SUBJECT: Responds to NRC request to update submittal ltr dtd 950804  
 redefining repair boundary for parent tube behind HEJ sleeve

Donald C. Cook Nuclear Plant Unit 1  
TECHNICAL SPECIFICATION CHANGE TO ALLOW FOR REPAIR OF HYBRID  
EXPANSION JOINT (HEJ) SLEEVED STEAM GENERATOR TUBES  
REQUEST FOR ADDITIONAL INFORMATION (RAI)

HEJ SLEEVED TUBE STRUCTURAL INTEGRITY LIMITS

DONALD C. COOK NUCLEAR PLANT UNIT 1

FIGURE 3-1  
REVISED HEJ SLEEVED TUBE REPAIR BOUNDARY for  
PARENT TUBE INDICATIONS

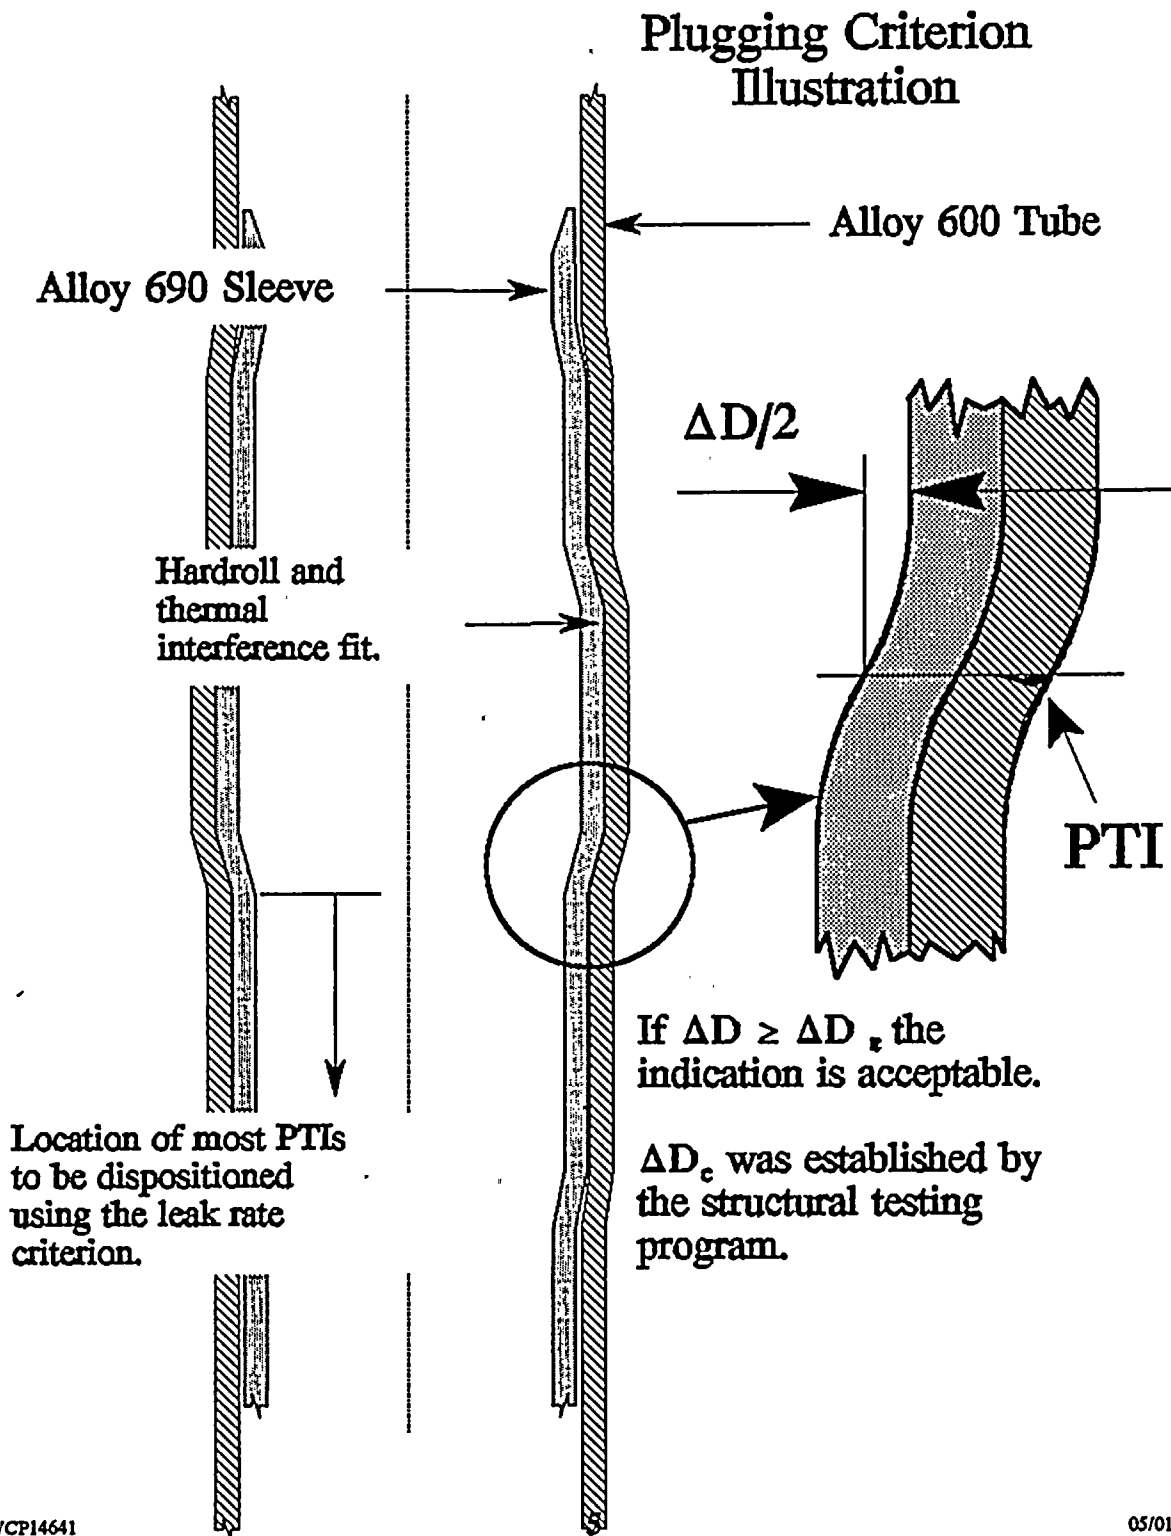
2. Each sleeved tube permitted to remain in service through application of the revised pressure boundary criteria with a PTI elevation corresponding to a diameter difference between the peak hardroll diameter of 0.003 to 0.013 inch is assigned a bounding SLB leakage allowance of 0.025 gpm. This value is a conservative estimation of SLB leakage. The HEJ sleeved tube leakage allowance is added to the predicted leakage from all other sources, such as tubes left in service as a result of the application of the voltage based repair criteria for tube indications at TSP elevations (IPC), to verify that offsite dose does not exceed 10% of the 10 CFR Part 100 guidelines. For PTIs located below the hardroll such that the diametral difference,  $\Delta D$ , between the peak hardroll diameter and sleeve ID at the PTI is greater than 0.013 inch, the SLB leakage may be neglected. The 0.025 gpm leakage allowance provides sufficient margin that any postulated leakage emanating from tubes with PTI  $\Delta D$  values of greater than 0.013 inch will be accounted for.

The revised repair boundary is illustrated on Figure 3.1. The revised repair boundary is applicable to the HEJ sleeved tubes in domestic Model 51 steam generators.
